Access Compliance Report

Public Rights-of-Way

Intersection ID: 14959	Main Street: REDDMAN_RD	Cross Street: CENTRAL_AV	Location: S
ADA ID: B25E894C4258	Ramp Type: PerpDiag	Initial Pass/Fail: Fail	Overall Compliance: No
		Severity Score: 10

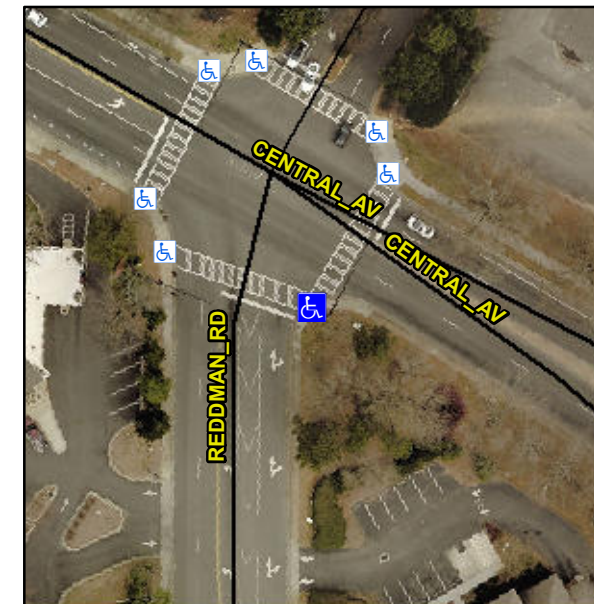
Not Found, R304.5.1

Compliance	Description	Data	Compliance	Description	Data
N/A	Ramp Length (in)	59.5	Yes	Ramp Slope (%)	7.7
No	Ramp Width (in)	47.5	Yes	Ramp XSlope (%)	3.9
N/A	Flare Type LT	N/A	N/A	Flare Type RT	N/A
N/A	Flare Slope LT (%)	N/A	N/A	Flare Slope RT (%)	N/A
N/A	Flare Traversable LT?	N/A	N/A	Flare Traversable RT?	N/A
N/A	Landing Length (in)	N/A	N/A	DWS Provided?	N/A
N/A	Landing Width (in)	N/A	N/A	DWS Contrast?	N/A
N/A	Landing Slope (%)	N/A	N/A	DWS Length (in)	N/A
N/A	Landing X Slope (%)	N/A	N/A	DWS Full Width?	N/A
N/A	Landing Curb? (Y/N)	N/A	N/A	DWS Offset (in)	N/A
N/A	Shared Landing?	N/A			
N/A	Gutter Ponding?	N/A	N/A	Gutter Slope (%)	N/A
N/A	Gutter Lip Ht (in)	N/A	N/A	Gutter X Slope (%)	N/A
N/A	Painted X Walk1?	Yes	N/A	Painted X Walk2?	Yes
	X Walk 1 Direction	To NE		X Walk 2 Direction	To NW
N/A	X Walk 1 Width (in)	110.5	N/A	X Walk 2 Width (in)	109.5
	X Walk 1 Slope (%)	1.4		X Walk 2 Slope (%)	6.5
	X Walk 1 X Slope (%)	6.4		X Walk 2 X Slope (%)	0.4

Remove & Replace Curb Ramp With Two New Directional Ramps or Equivalent.
